122 MARINE PARADE

MINOR CHANGE APPLICATION TO MCU/2025/155 | NOVEMBER 2025

REQUEST TO CHANGE AN EXISTING DEVELOPMENT APPROVAL – PROPOSED CHANGE (MINOR CHANGE) TO DEVELOPMENT PERMIT FOR MATERIAL CHANGE OF USE (IMPACT ASSESSMENT) FOR MULTIPLE DWELLINGS (45 UNITS)

DRAWING NO. DA2.101
BASEMENT FLOOR PLAN

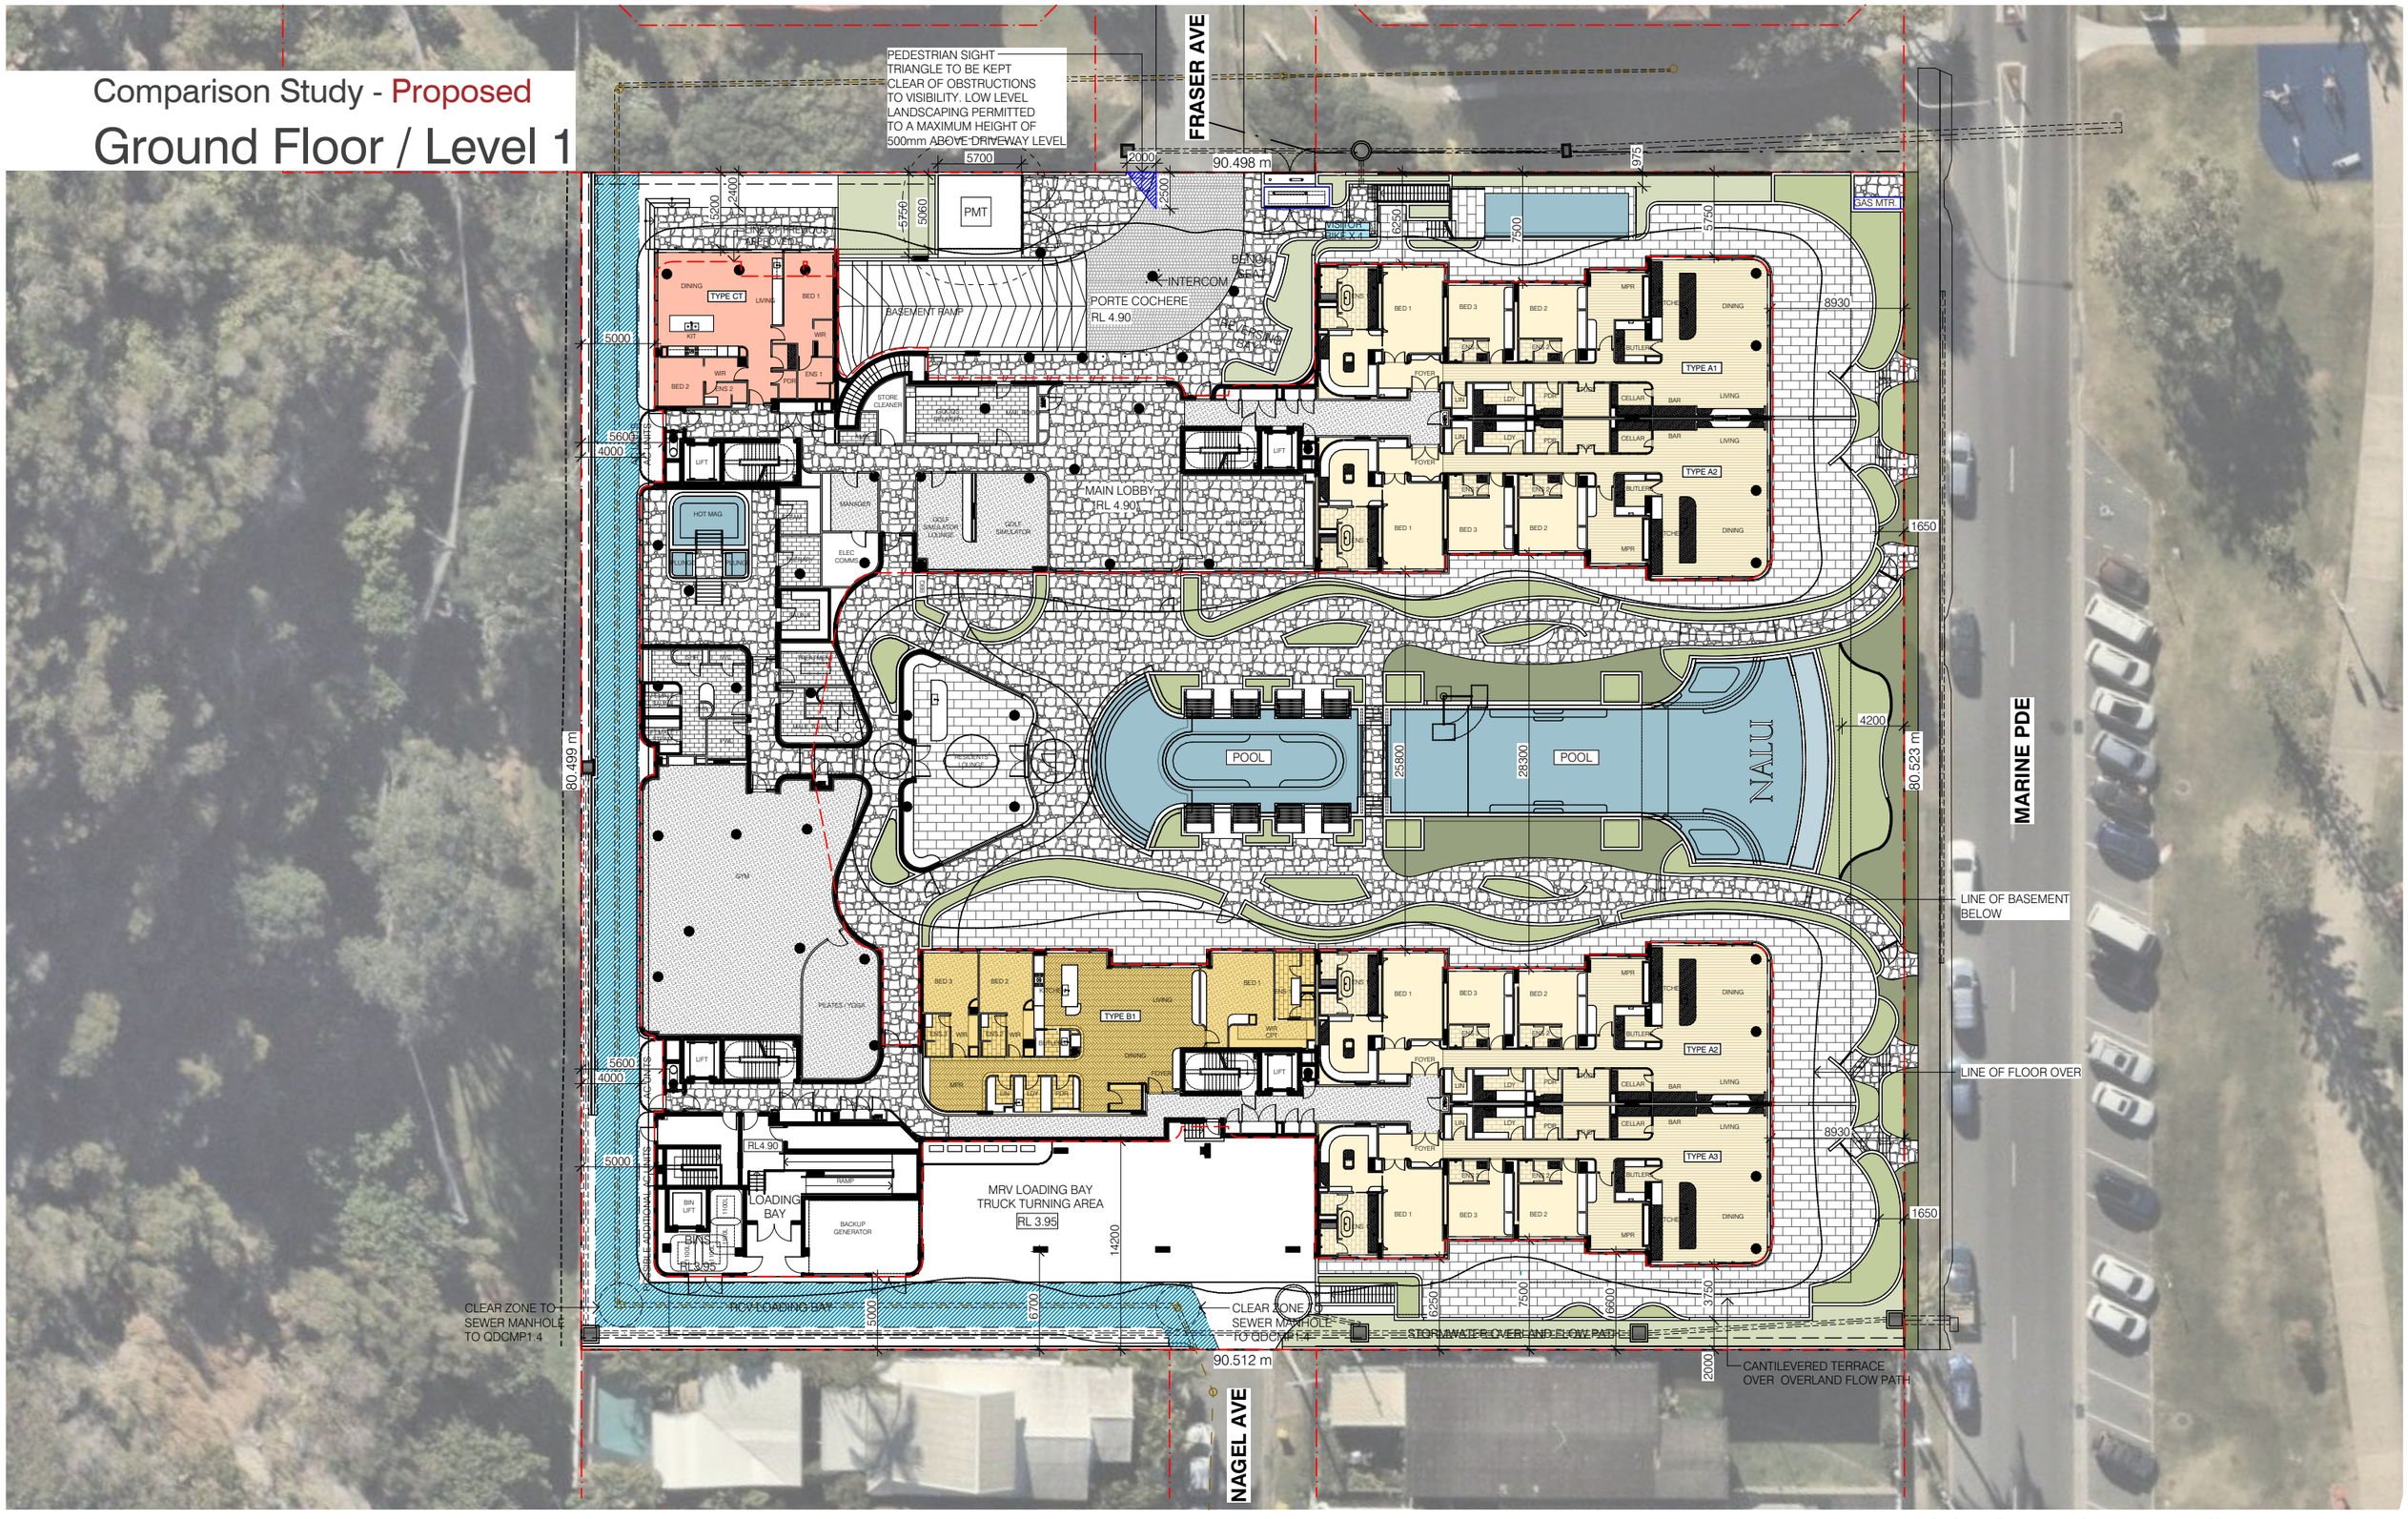
- Changes to the internal layout of the basement parking and storage spaces, to provide an increase in residential car parking spaces from 136 spaces as approved to 150 spaces as proposed.

- Minor change to size of water pump room / water filter adjacent to the fire pump room and fire escape stairs at northern edge of basement.
  - Minor reconfiguring of 16 resident bicycle parking spaces in north-western corner of basement.
